340 Rte 16B • Ctr Ossipee, NH 03814 800-543-3580 • 603-539-4538 MiteeBite.com MADE IN THE USA

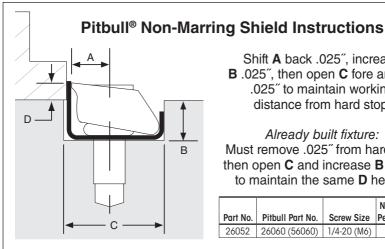
Shift A back .025", increase B .025", then open C fore and aft .025" to maintain working distance from hard stop.

Already built fixture: Must remove .025" from hard stop then open C and increase B .025" to maintain the same **D** height.
